STANDARDS AUSTRALIA/STANDARDS NEW ZEALAND

Amendment No. 2
to
AS/NZS 60155:2000
Glow-starters for fluorescent lamps

CORRECTION

SUMMARY: This Amendment applies to the Figure 1.

Figure 1 - Dimensions of starters

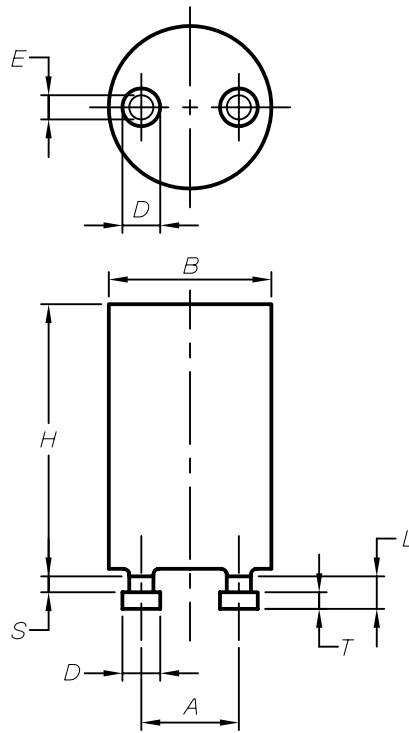
Delete Figure 1 and *replace* with the following:

Dimension	Min.	Max.
A	12,5	12,9
B	-	21,5
D	4,7	5,0
E	2,8	3,2
H	33,0	36,0
L	-	4,3
S	1,7	-
T	1,9	2,2

The starters are checked with the gauges shown in figures 6, 7 and 8.
